VERMONT YANKEE NUCLEAR POWER STATION

AMENDMENT TO FACILITY OPERATING LICENSE

Amendment No. 93  
License No. DPR-28

SAFETY EVALUATION BY THE OFFICE OF NUCLEAR REACTOR REGULATION

Figure 3.6.1  
 Reactor Vessel Pressure  
 Temperature Limitations  
 for Operation Through 1.79 EBMWH  
 $RT_{NDT}$  @ 1/4T = 69°F

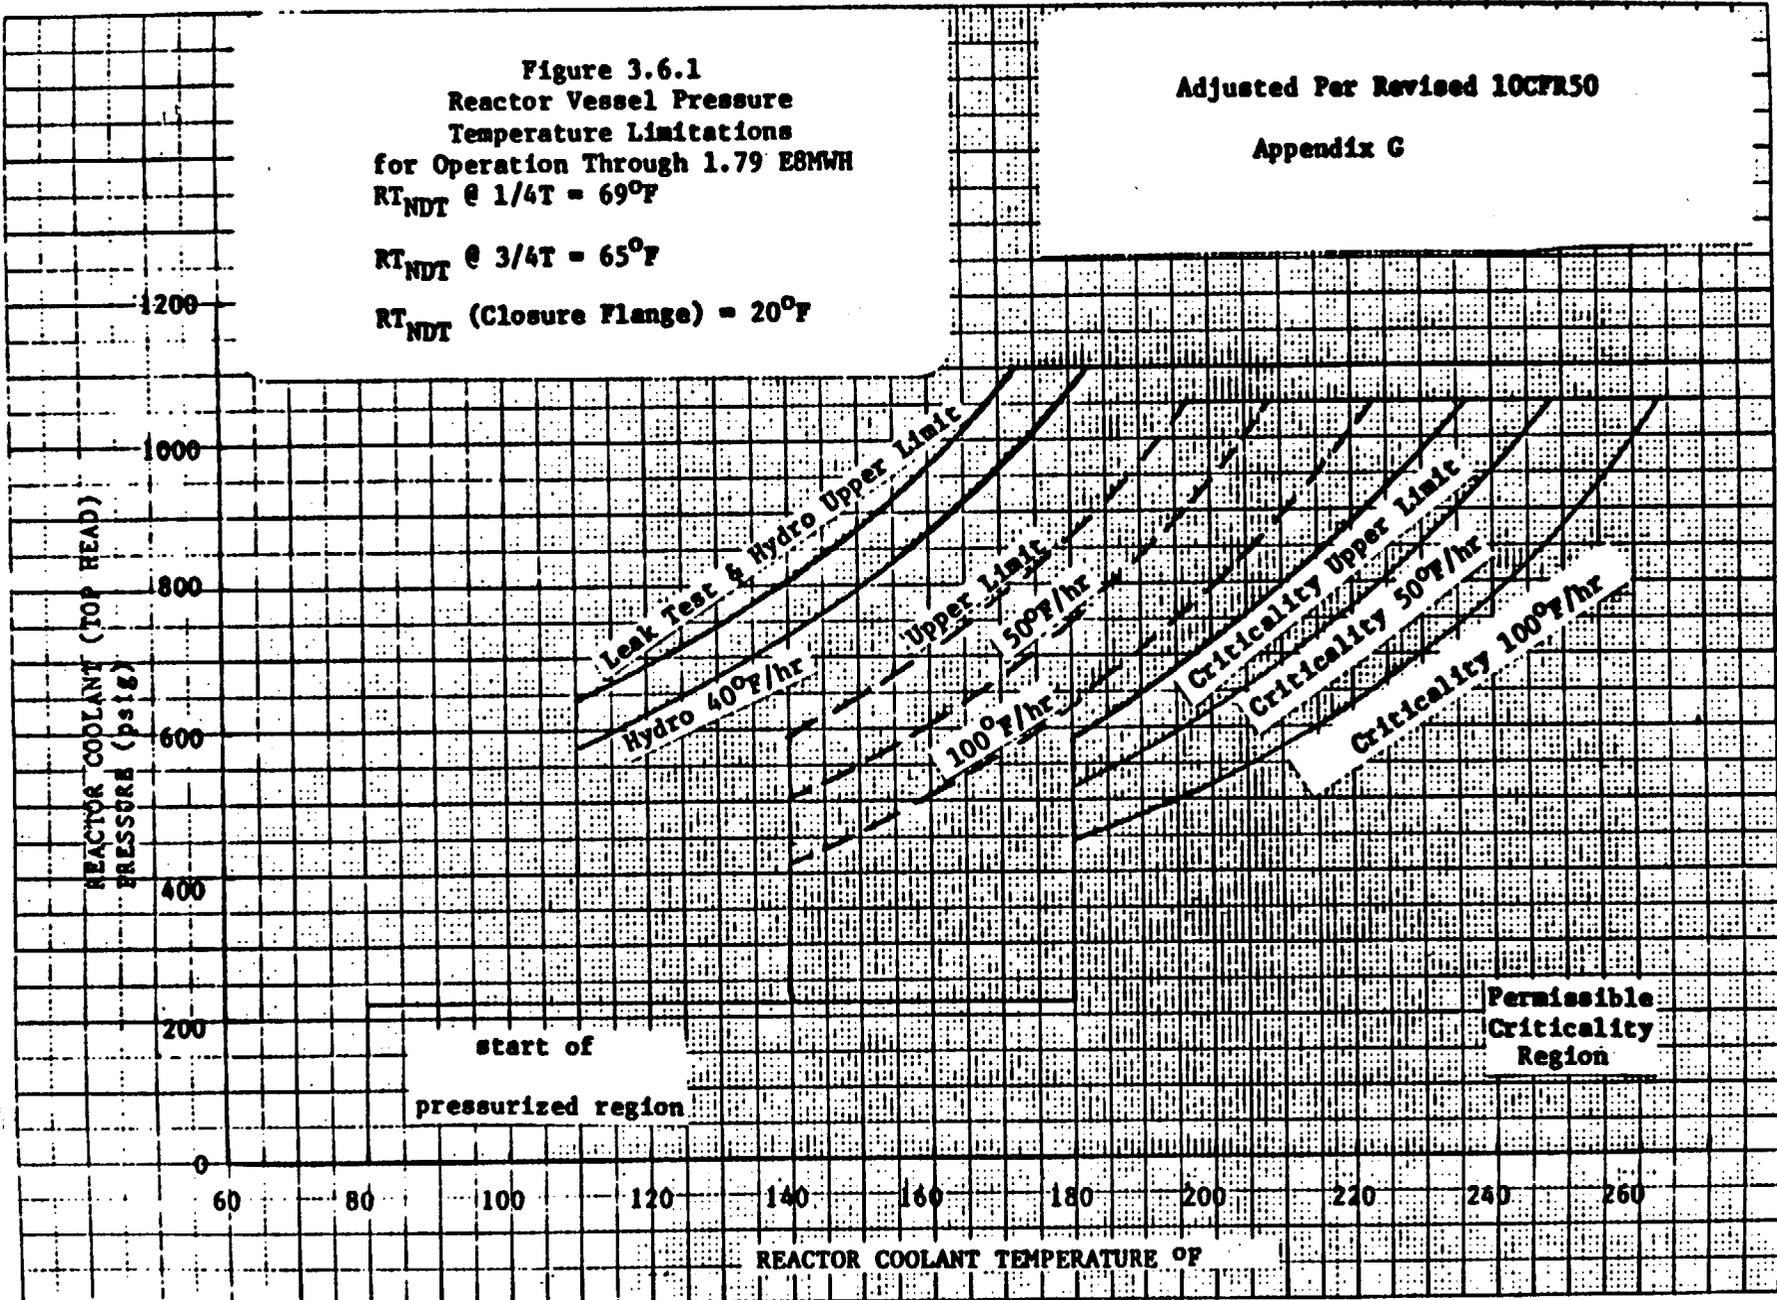
The amendment revises the Technical Specifications to accommodate shifts in transition temperature for the reactor pressure vessel materials that were induced by radiation damage. These shifts are accounted for by revision of the plant pressure-temperature limits for heating up and cooling down the reactor vessel. Periodic review and adjustment, if necessary, of the curves to account for the effects of irradiation are required by 10 CFR 50, Appendices G and H.

This change adjusts the reactor vessel pressure and temperature limitations to compensate for the effects of increased neutron exposure to permit operation to a cumulative energy output of  $1.790 \times 10^6$  MWh(t). This adjustment is necessary because the existing curves are limited to an energy output of  $1.33 \times 10^6$  MWh(t), a value which is expected to be reached during 1986. This change also adjusts the fluence factor and fluence vs. thermal energy curves to incorporate revised fast neutron fluence calculations. The licensee submitted clarifying information by letter dated November 21, 1985.

The new curves incorporate results from the surveillance capsule removed in March 1983 and new tests performed on unirradiated specimens for archival base, weld, and heat affected zone materials.

Only two plates lie in the vessel belt line, pieces 1-14 and 1-15. The limiting plate has been established as piece 1-14 which is the surveillance plate. An initial  $RT_{NDT} = 40^{\circ}F$  was established for this plate. From the Battelle tests, the shift in  $RT_{NDT}$  was  $19^{\circ}F$  at a fluence of  $4.3 \times 10^{16}$  n/cm<sup>2</sup>. Utilizing the calculational procedure of the proposed Regulatory Guide 1.99, Revision 2, a shift of only  $4.7^{\circ}F$  results at this fluence. The Chemistry Factor (CF) for piece 1-14 is 76, representing a copper content of 0.11 weight percent and a nickel content of 0.68 weight percent. The measured shift is within one standard deviation of that calculated (Regulatory Guide 1.99, Revision 2 assumes  $1\sigma = 17^{\circ}$  for base metal). However, because the calculational procedures of the Regulatory Guide results in a less conservative prediction of shift, a modified Regulatory Guide fluence factor curve was developed. The modified curve utilizes the same curve shape and damage prediction as Regulatory Guide 1.99, Revision 2, but passes through the Vermont Yankee surveillance capsule data point. In effect, the fluence factor parameter in the Regulatory Guide 1.99 reference temperature shift equation is multiplied by a factor of 4.17 to duplicate the measured  $RT_{NDT}$  shift at Vermont Yankee. Future shift values can then be determined from this curve until the next surveillance specimen is removed.

The pressure-temperature limit lines, shown on Figure 3.6.1, for reactor criticality and for inservice leak and hydrostatic testing have been provided to assure compliance with the minimum temperature requirements of Appendix G to 10CFR50 for reactor criticality and for inservice leak and hydrostatic testing.

We have reviewed the calculations which form the basis for the proposed change and find them acceptable. The proposed changes to the Technical Specifications relating to the pressure and temperature limits for hydrostatic and leak tests, subcritical/critical heat up and cool down, and operation meet the requirements of 10 CFR 50, Appendix G, Regulatory Guide 1.99, Revisions 1 and 2 and Appendix G, Section III of the ASME Code. The proposed changes are acceptable for incorporation into the Technical Specifications.
